Response to Submissions | New Residential Community 2 and 2A Bullecourt Avenue (SSD- 97092958)

This Submissions Report has been prepared by Beam Planning on behalf of Mirvac Residential (NSW) Developments Pty Ltd (the Applicant) in relation to the State Significant Development Application (SSDA) (SSD-97092958) for a new residential community located at 2 and 2A Bullecourt Avenue, Milperra (the site).

Figure 1 Habitat features within the site

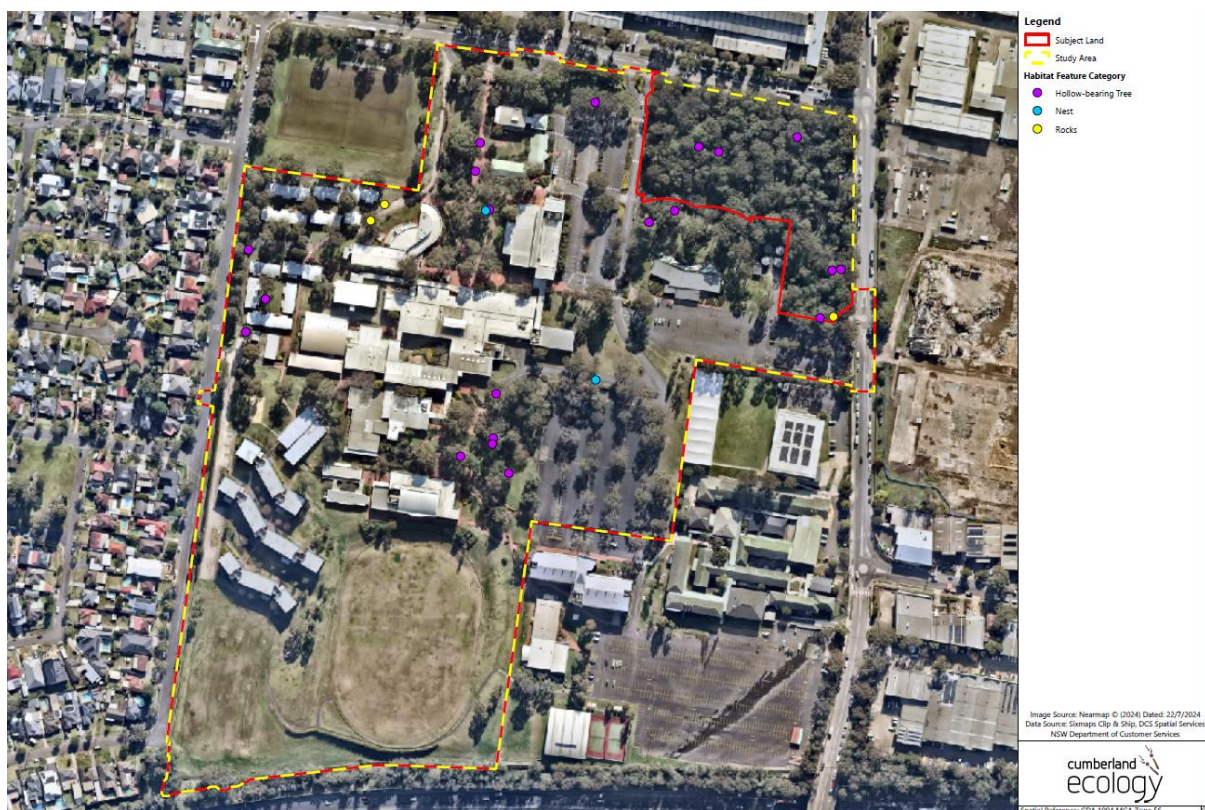
Council noted that the C2 Environmental Conservation zoned land cannot be utilised as justification for avoidance of impacts in accordance with the *State Environmental Planning Policy (Biodiversity and Conservation) 2021* and *Environmental Protection and Biodiversity Conservation Act 1999*. Council have therefore requested that avoidance be demonstrated elsewhere on the site.

Chapter 7 of the updated BDAR (refer **Appendix D**) provides a discussion of the avoidance of impacts for the project, including the retention of 22 CPW trees within the E1 Local Centre zoned land, CPW along the western boundary of Milperra Reserve, and retention of planted native and exotic trees within the proposed parklands, which offer connected canopy and pre-existing hollows, as shown in the below **Figure 1 and 2**.

Figure 3 Vegetation removal and retention proposed

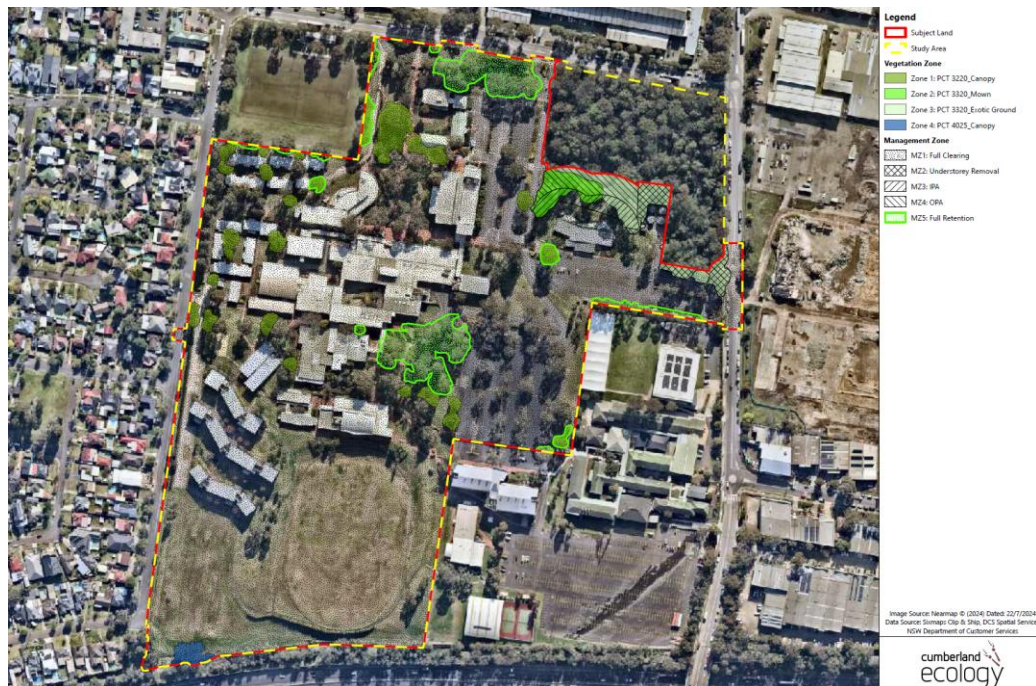
Council noted that the proposed development incurs impacts to the C2 Environmental Conservation zoned land as a result of the Horsley Road intersection design. It is important to note that the C2 Environmental Conservation zoning was applied by the DPHI during the former Planning Proposal via a desktop study, and did not take into account the on-ground conditions. Section 8.6 of the updated BDAR discusses the impacts to this land.

Within the study area specified in the BDAR, the C2 Environmental Conservation zoned land contains a pre-existing road at the curved Horsely Road intersection. Under the Biodiversity Assessment Method (BAM), vegetation mapping uses tree canopy when applying the mapping to figures, and so updated mapping has

been provided in the BDAR to indicate more accurately the extent of vegetation removal (as shown in **Figure 3**).

This calculation methodology means that the impact area has been overestimated for the 'understorey removal' management zone (refer Figure 13 of the BDAR). The impacts are therefore presented in a more conservative light where canopy coverage is oftentimes interpreted as being overtop of equally important understorey plantings. As this management zone largely consists of the tree canopy over the existing road, this is not the case in this context of this project. Figure 4 of the BDAR has been updated to represent this more clearly.
